Product Change Notification STL Replacement – Molded Products with STL 355 by STL 242

PCN No: PCN-2023-03-24-335-242

Change Title: STL Replacement STL 355 by STL 242

01. Drawing

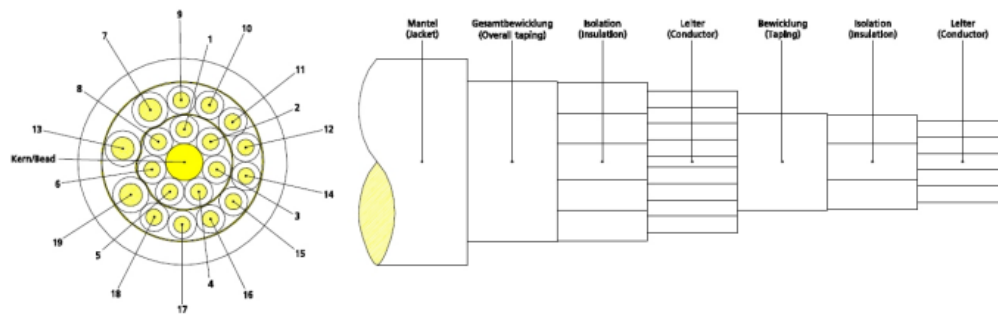
Difference Description	
Old Cable Jacket	NEW Cable Jacket
Outer jacket: Jacket material: PUR Jacket-diameter: Ø 11,60 -0,30 mm Jacket color: grey matt similarly RAL 7040	Outer jacket: Jacket material: PUR Jacket-diameter: Ø 11,60 ±0,30 mm Jacket color: black matt similarly RAL 9005

grey matt similarly RAL 7040

01. Drawing

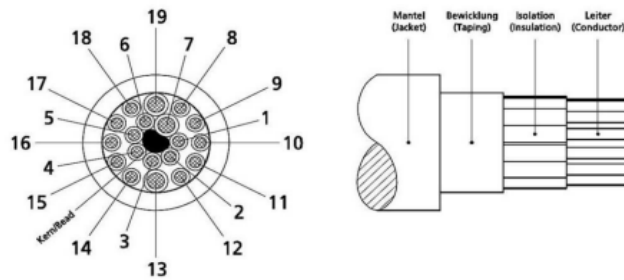
03.13. Outer jacket:
Jacket material: PUR
Jacket-diameter: Ø 11,60 ± 0,30 mm
Jacket color: black matt similarly RAL 9005
